CITY COUNCIL AGENDA ITEM

Subject: ANNOUNCEMENT OF PUBLIC HEARING – PRELIMINARY SITE PLAN REVIEW (SP JPLN2021-0028) - Proposed Golden Villas One Family Residential Cluster, South side of Square Lake, West of Dequindre (PIN 88-20-12-200-031 & 88-20-12-200-035), Section 12, Currently Zoned R-1C (One Family Residential) District

Preliminary Site Condominium Cluster Review For City of Troy, Michigan

Project Name:	Golden Villas
Plan Date:	February 28, 2022
Location:	South of E. Square Lake, west of Dequindre
Zoning:	R-1C, One-family Residential District
Action Requested:	Preliminary Site Condominium Cluster Approval
Required Information:	Deficiencies noted.

TREE PRESERVATION PLAN

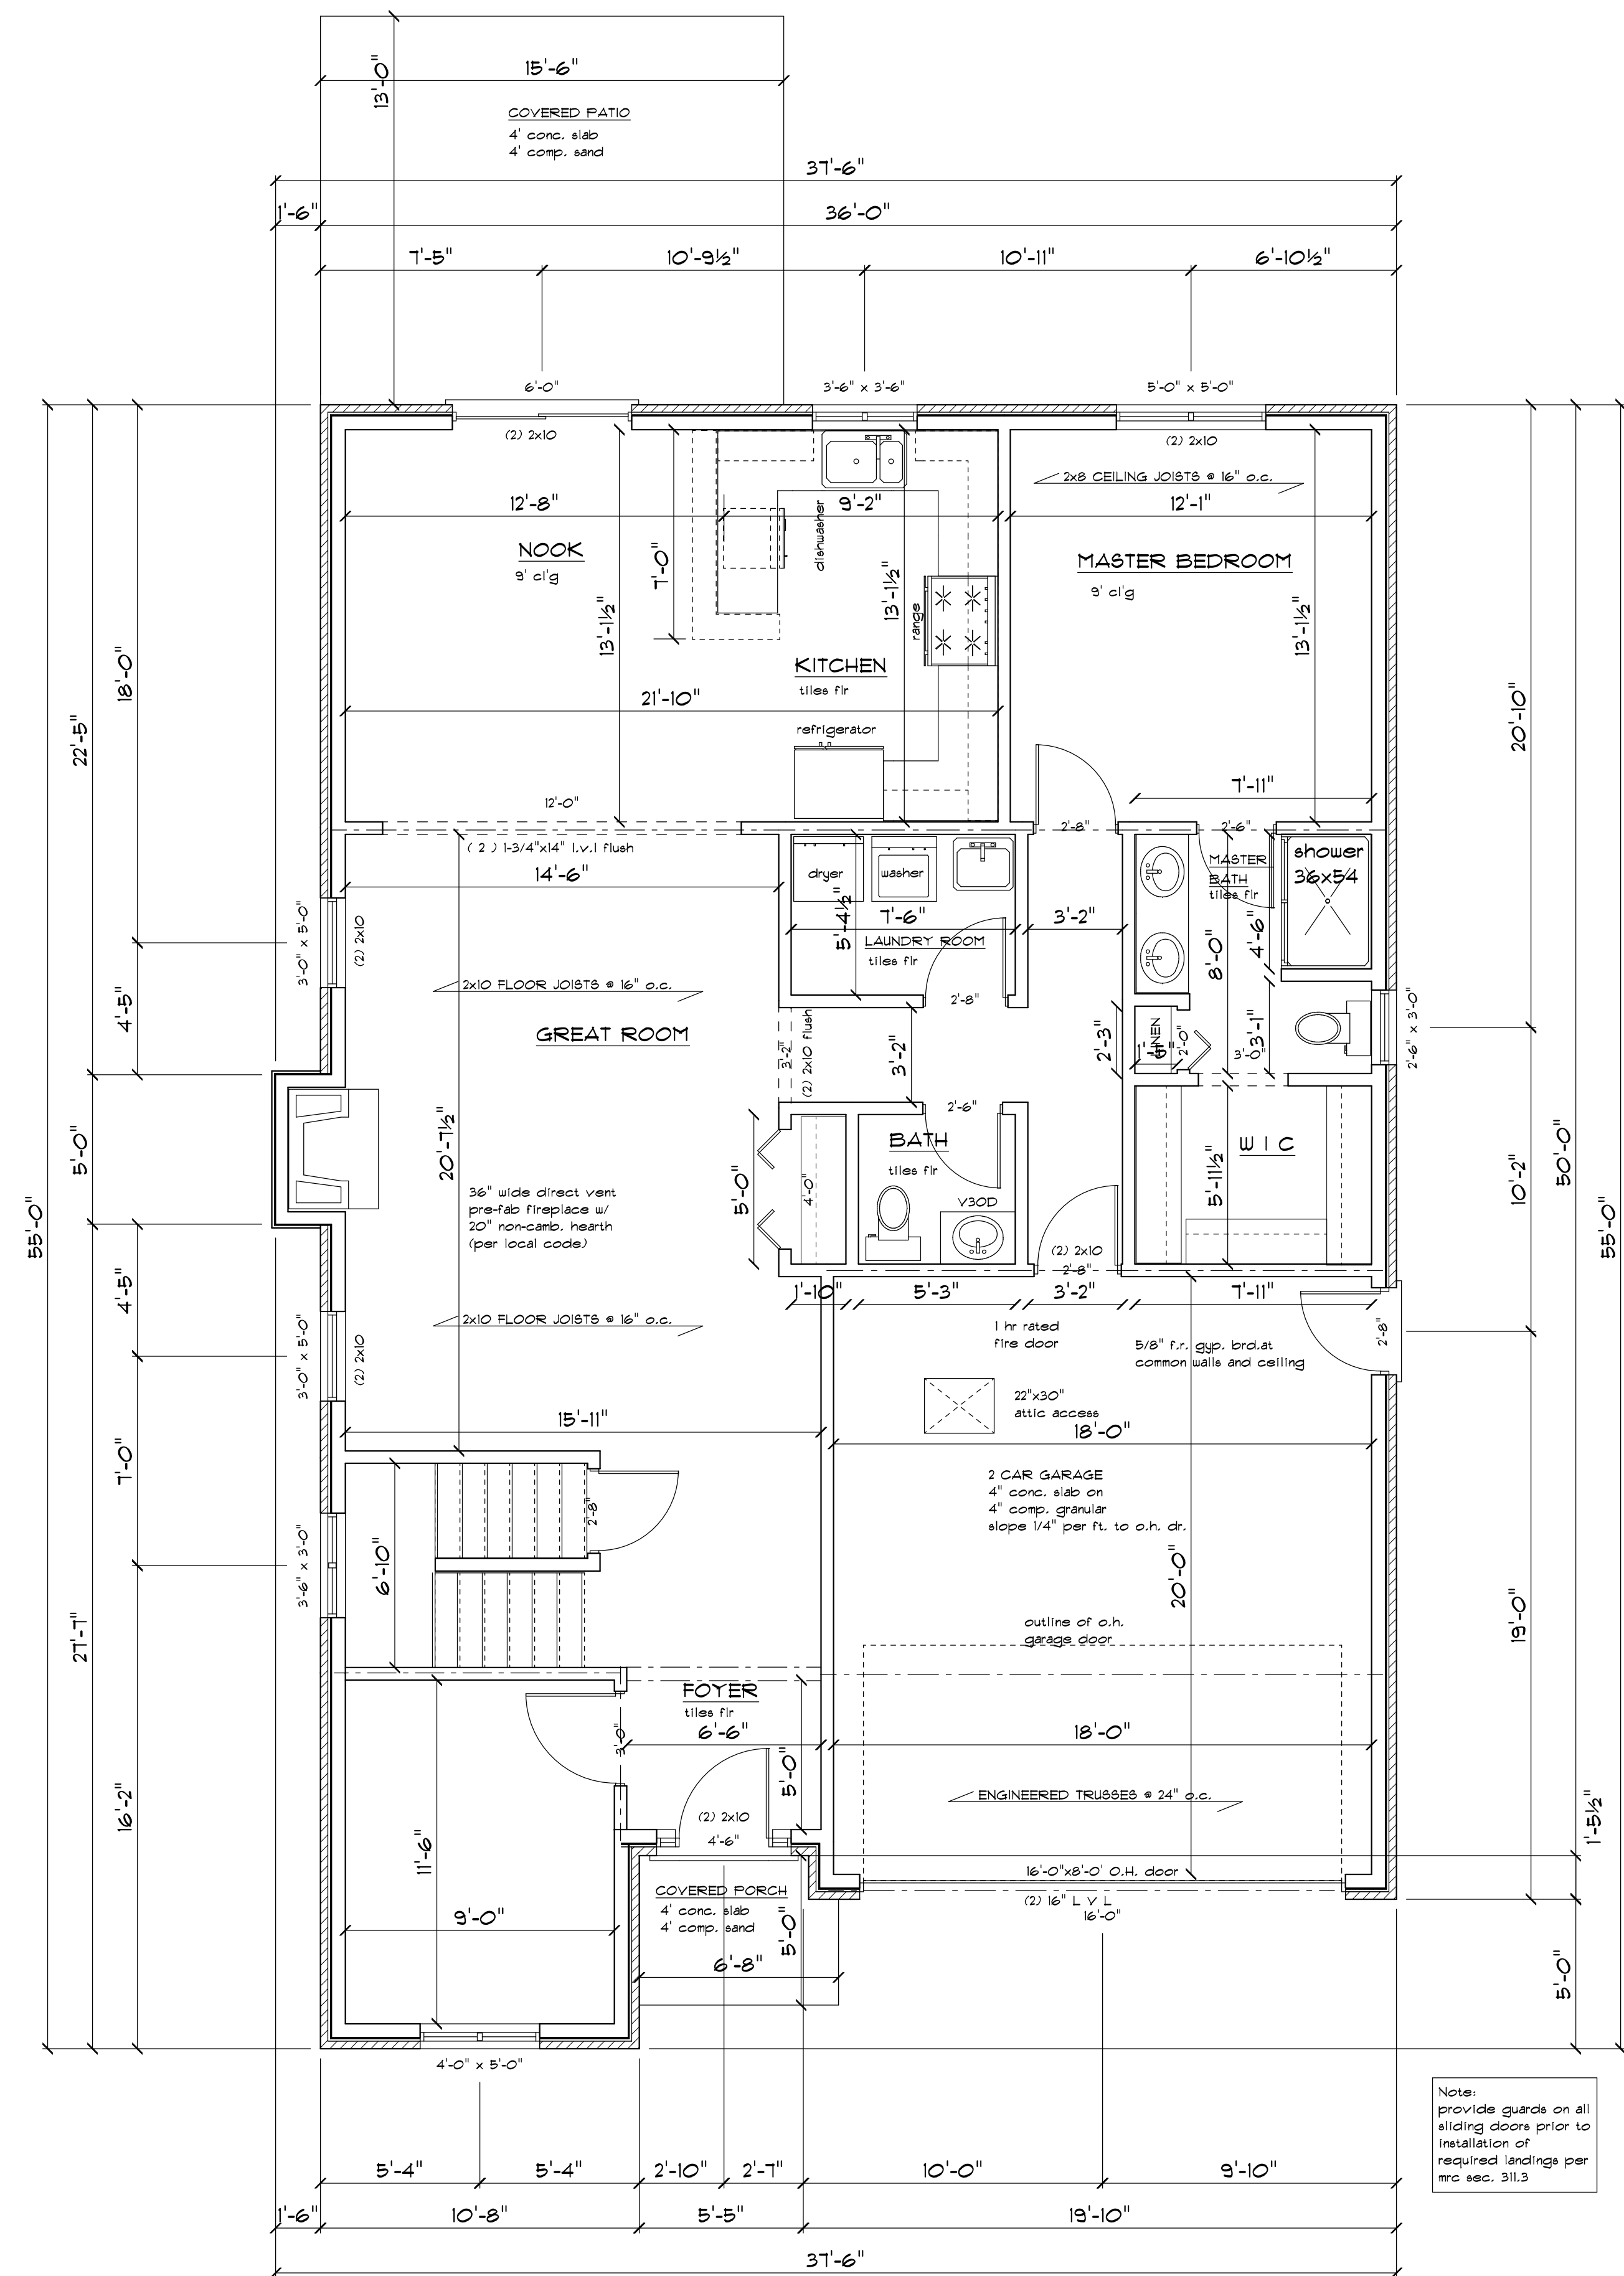
Woodlands: A tree survey has been provided to inventory the natural features that exist onsite. The survey identified a total of 81 trees on site. Many of the trees are invasive. There is an especially high number of Cottonwoods. The applicant has identified a total of 9 landmark trees and 40 woodland trees, preserving 2 and 14, respectively. Full replacement and preservation details are shown in **Table 2**.

FRONT ELEVATION

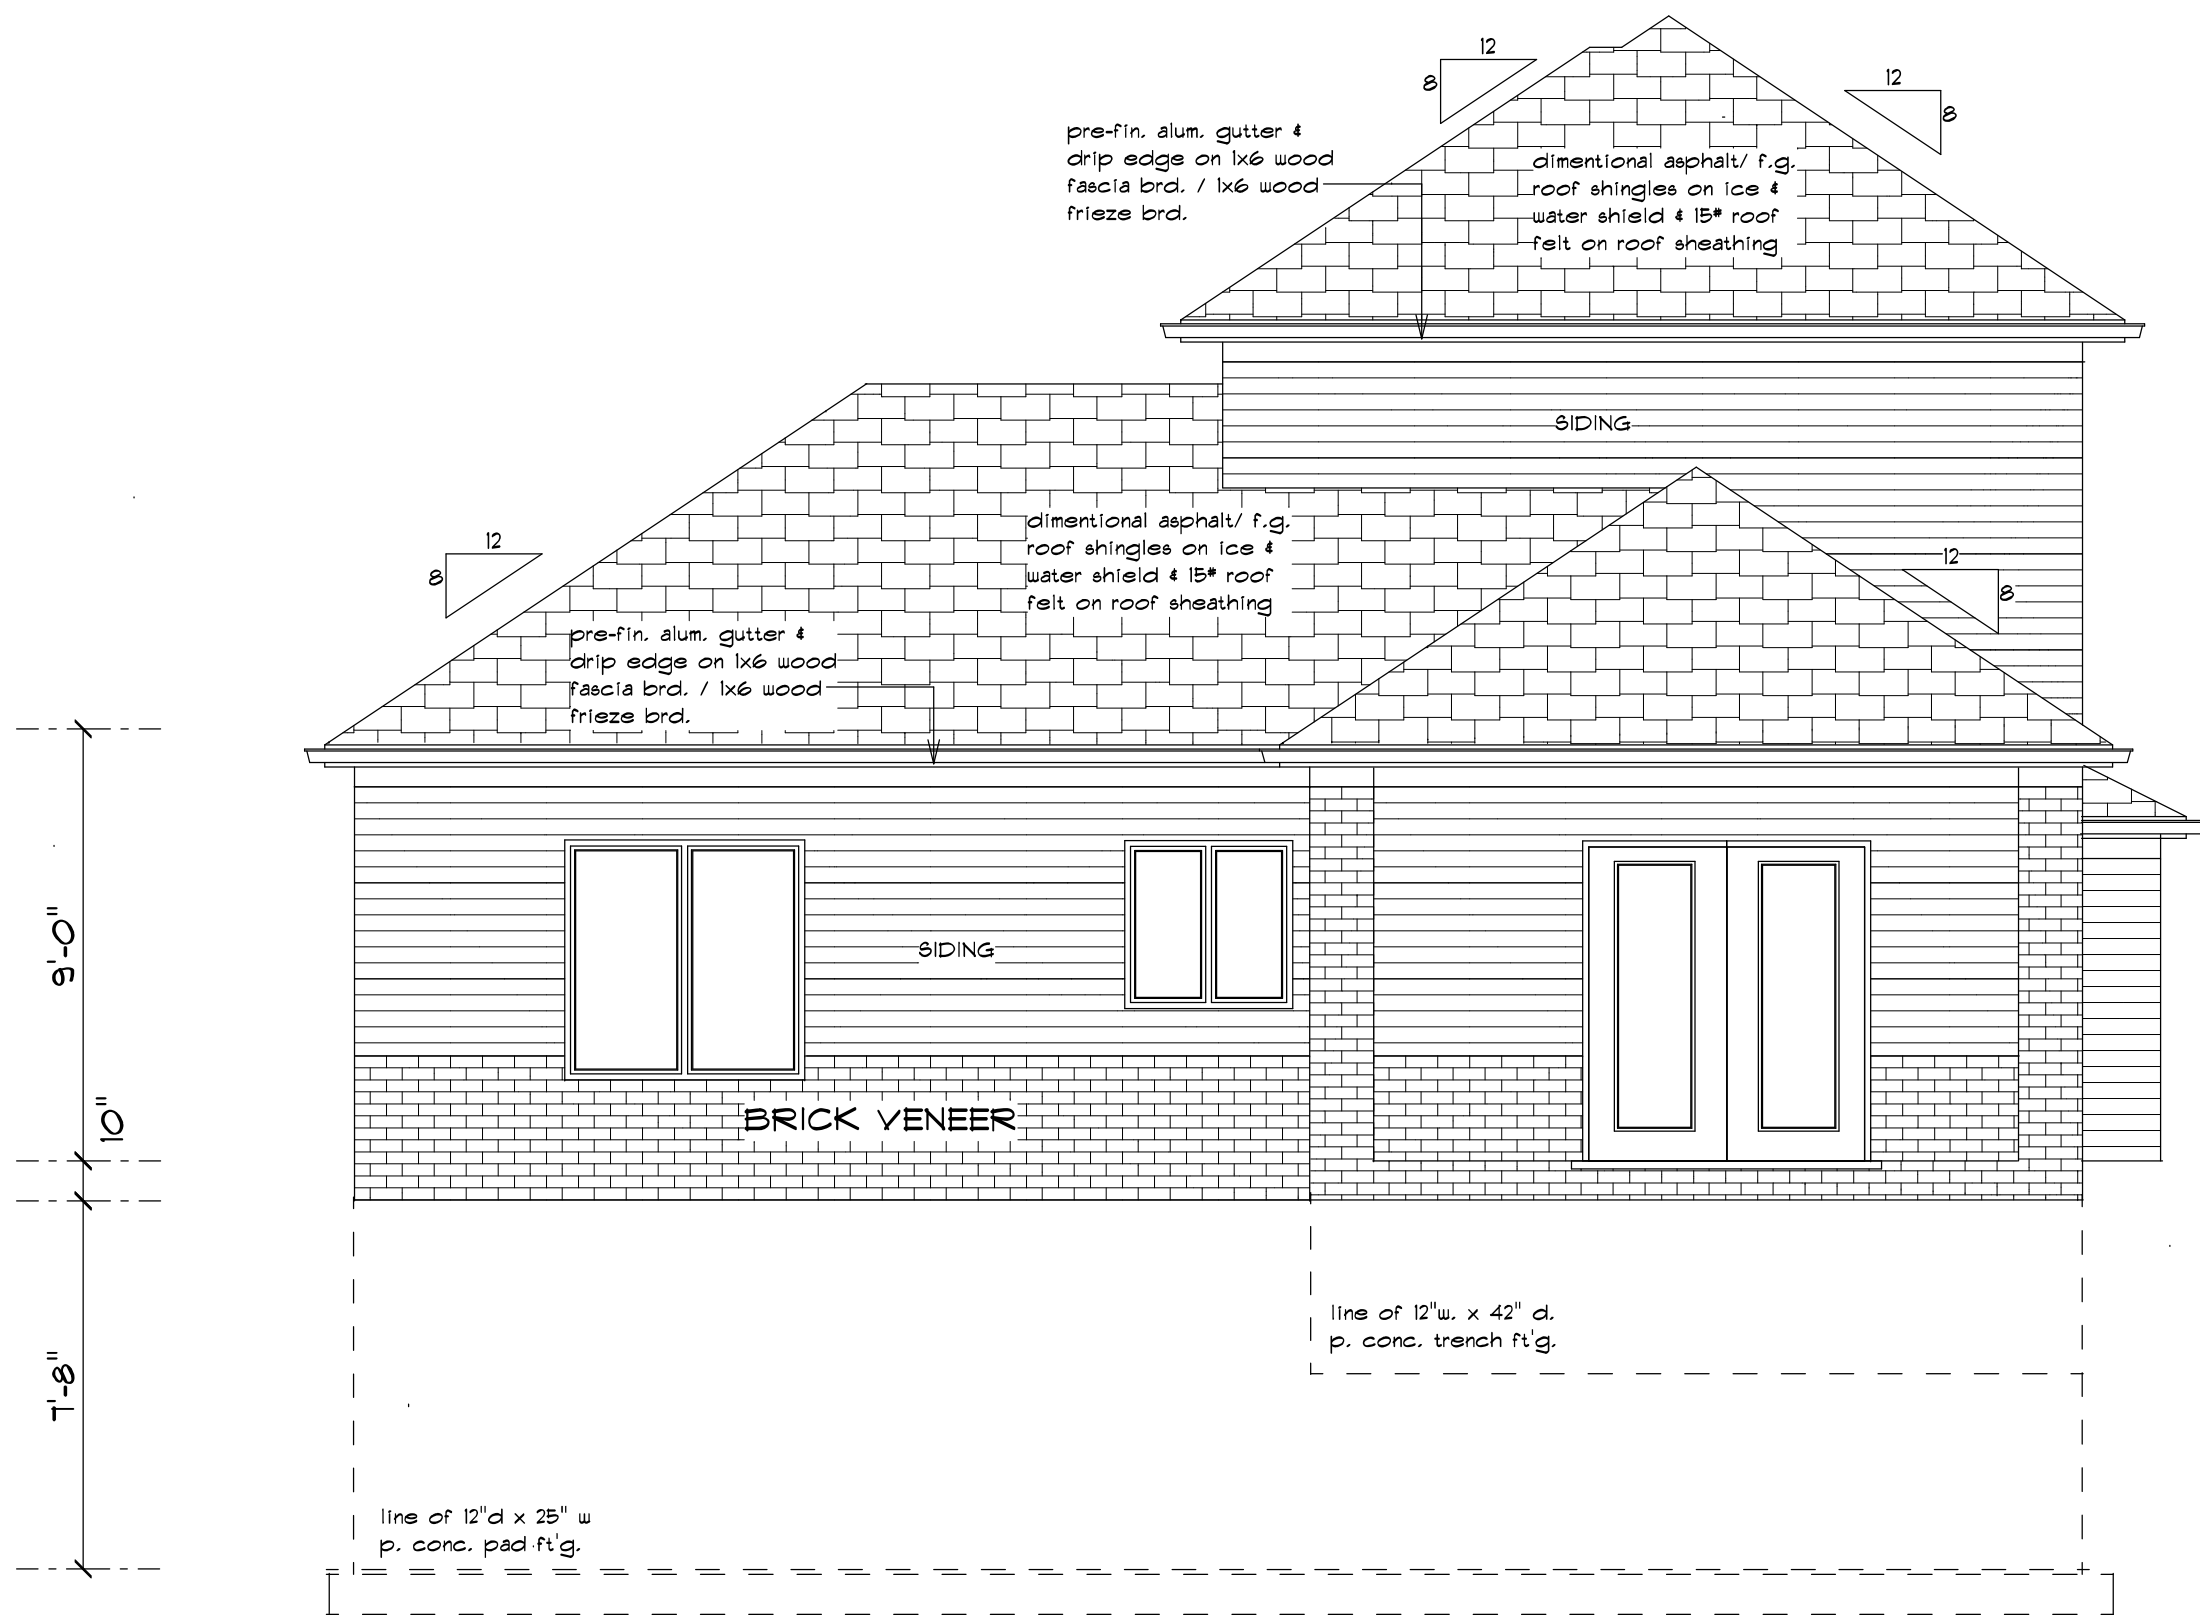
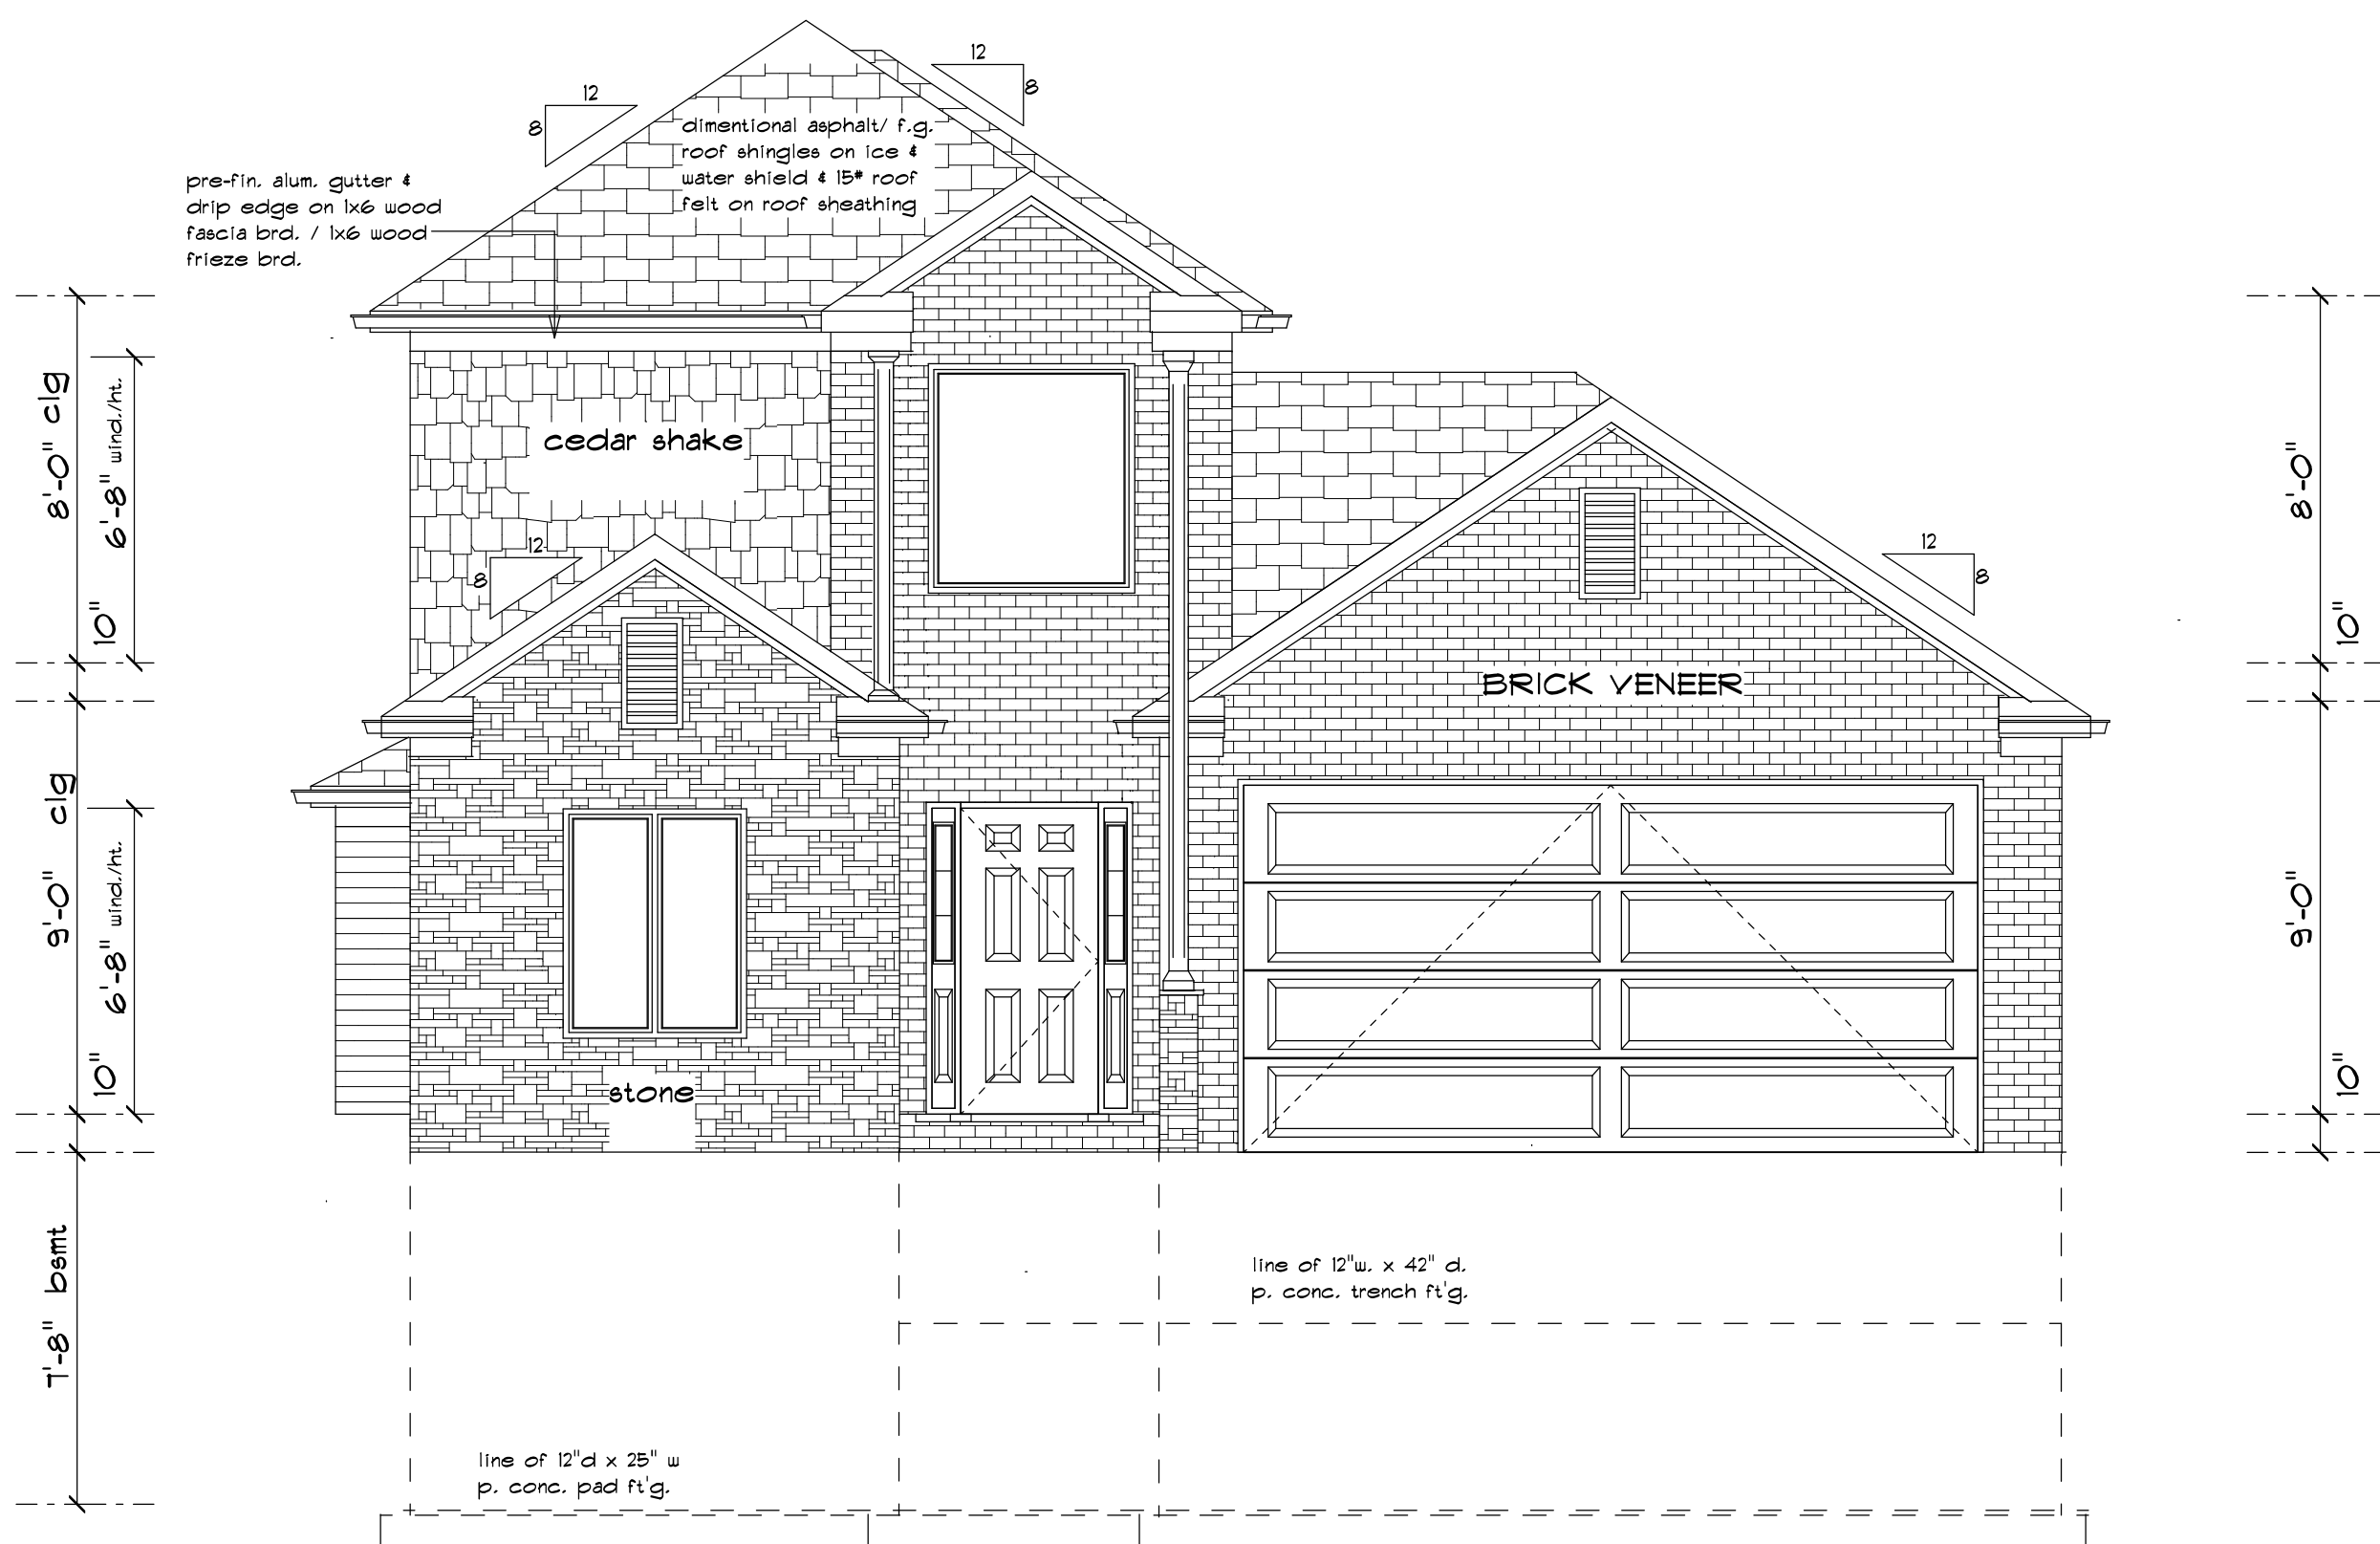
The applicant has submitted one housing options with a square footage up to 1,900. The applicant shall supply additional housing elevation options. Materials include brick, stone, and cedar veneer.

Items to be Addressed: Provide additional housing elevation options
